## **ATTACHMENT 1: COMMENT LETTERS**

**Rincon Hill Plan: Draft Environmental Impact Report (DEIR)**

DIAGRAM 2

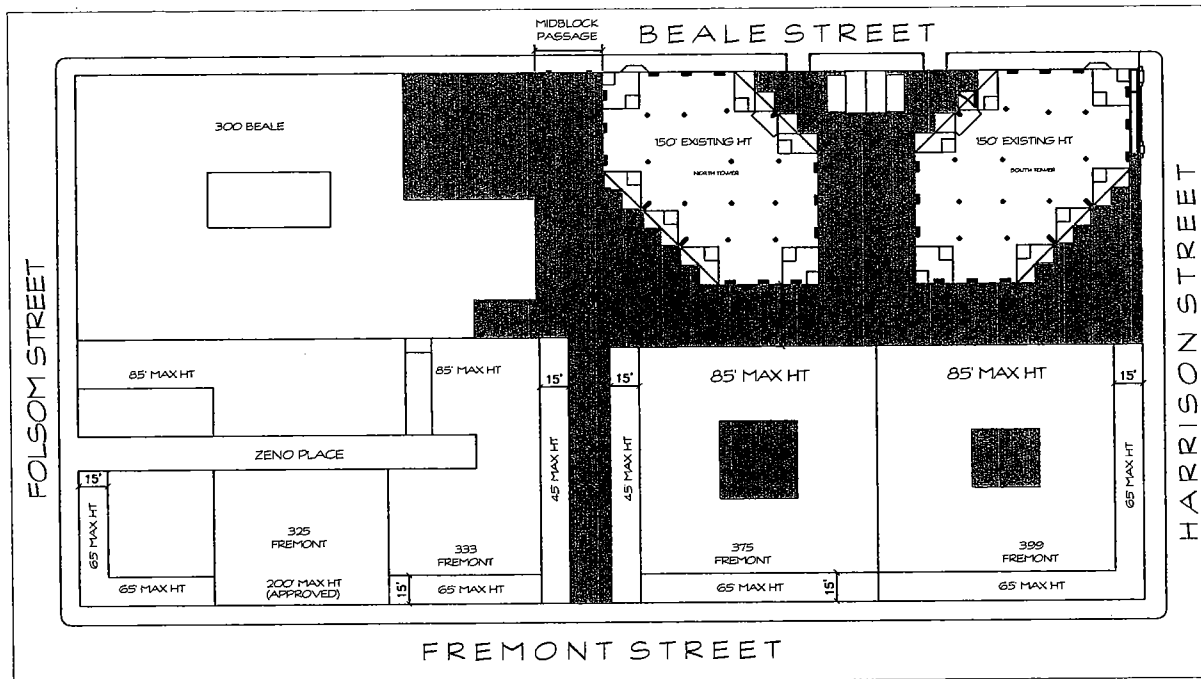
The Proposed Height District Map, Figure 5 on page 11 of the September 25, 2004 Rincon Hill Plan DEIR is inaccurate because it shows a possible tower height of 250-feet for 375 Fremont Street and 440-feet for 399 Fremont.

Therefore, this drawing should serve as a replacement to Figure 5 for the "Preferred Option".

DIAGRAM 1

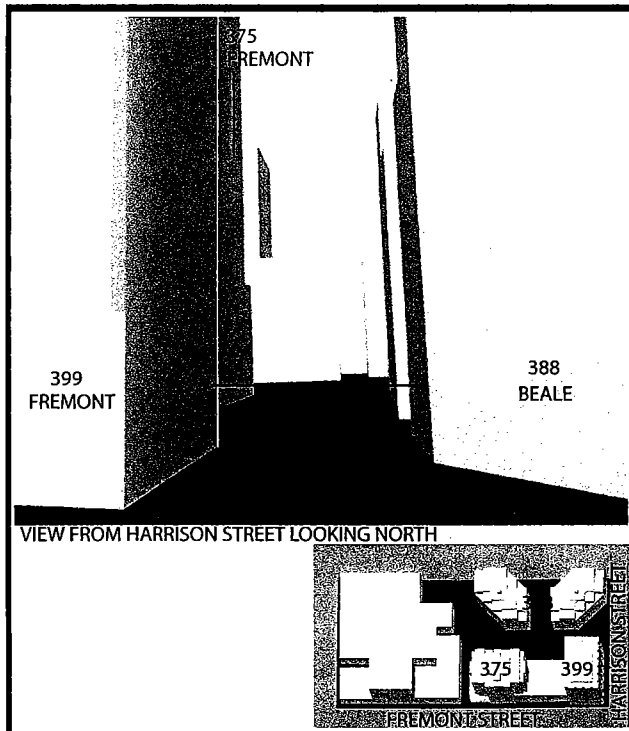
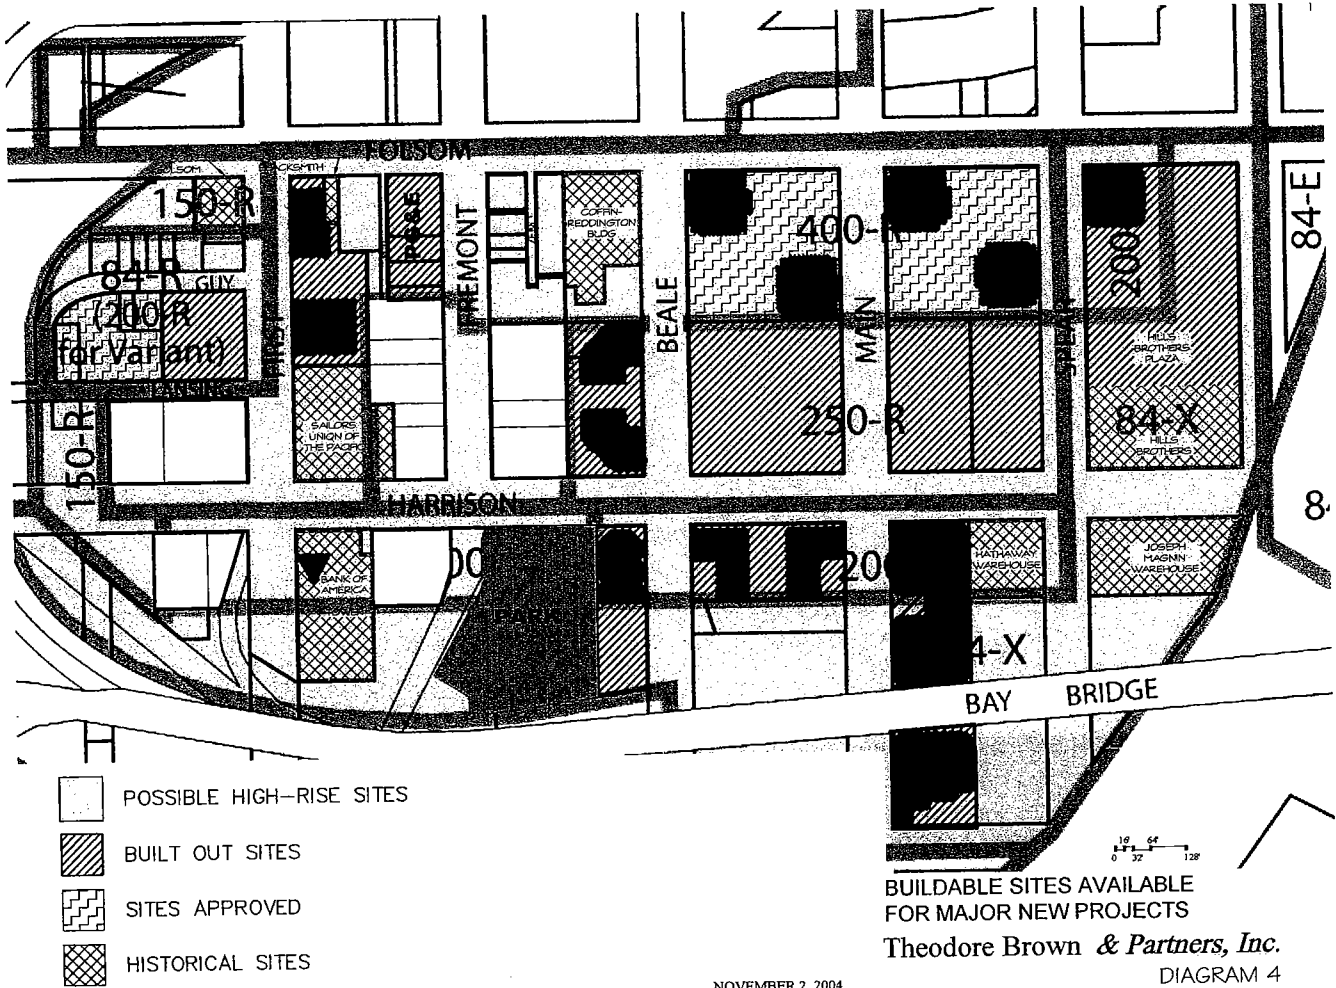
The diagram above shows that two towers built, one at 375 Fremont and one at 399 Fremont, with an 82.5' tower separation would provide a larger amount of ground level usable open space when compared to the proposed "Preferred Option."

DIAGRAM 8

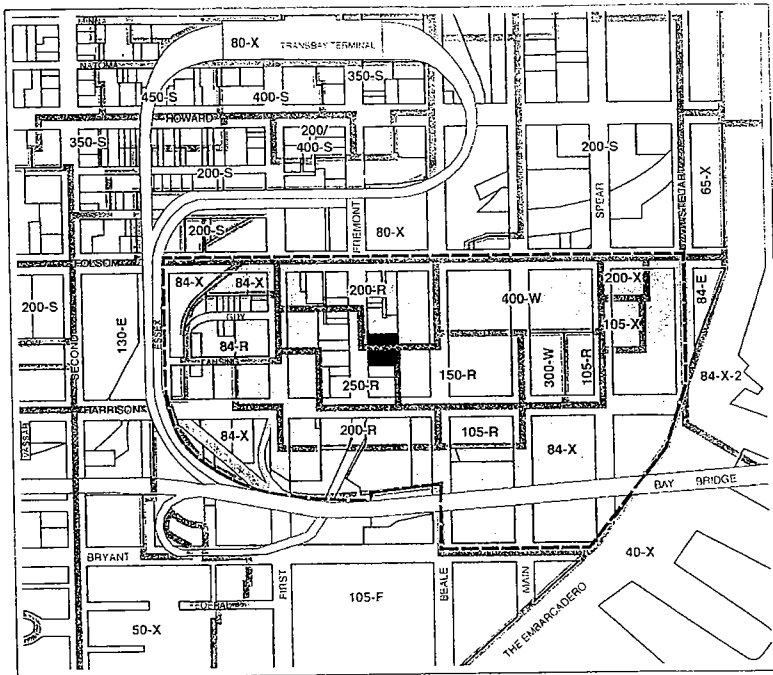
This is a copy of the September 25, 2004 Rincon Hill Plan Draft Environmental Impact Report, Case No. 2000.1081E, Figure 4 Existing Height and Bulk Districts. This plan shows the property at 375 Fremont Street, shown in red, bisected in the middle of the east-west direction by the height restriction line. This illustration represents an incorrect placement of the height restriction line. Its correct placement should be placed to the north side of the 375 Fremont property.

DIAGRAM 10

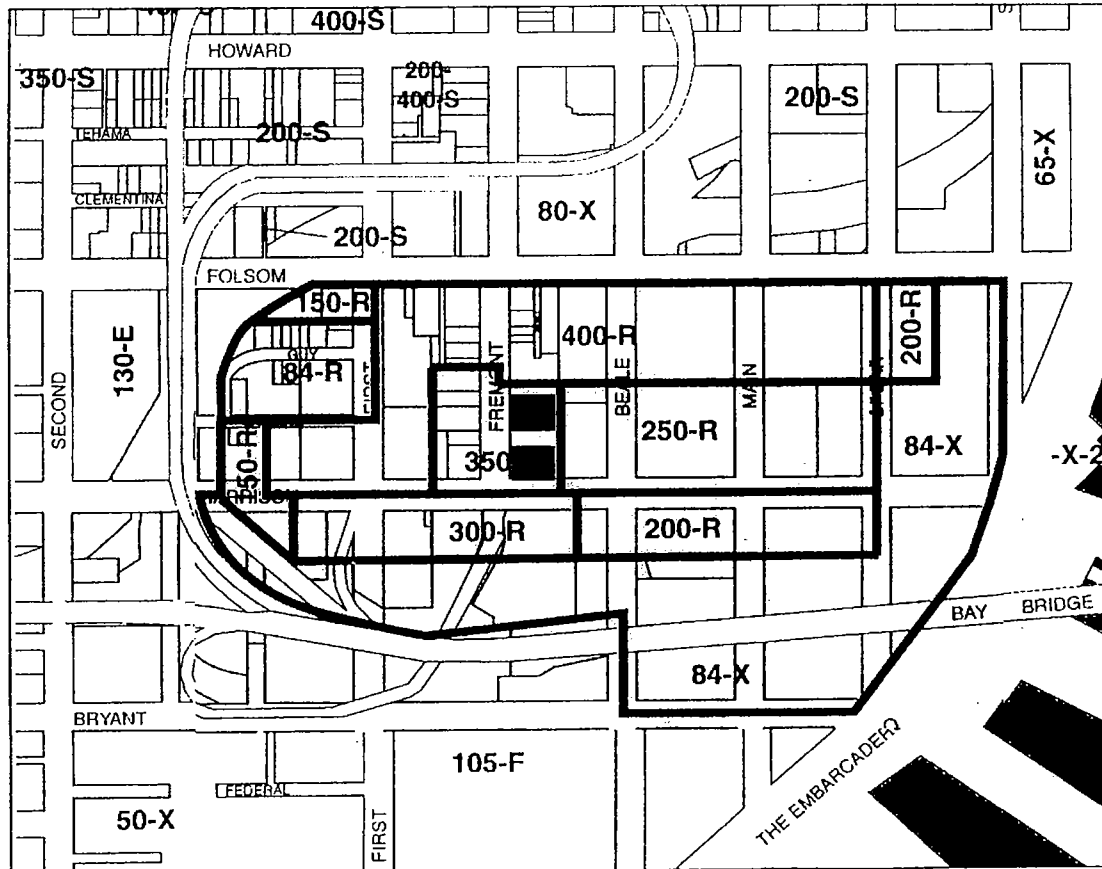
This is a copy of the March 20, 2002 Rincon Hill Mixed Use District EIR Draft, Planning Department Case No. 2000.1081 on the Proposed Height and Bulk Districts Figure 5, showing the height restriction line to the north of the 375 Fremont property as well as a 350-foot height restriction for the properties 375 Fremont and 399 Fremont.
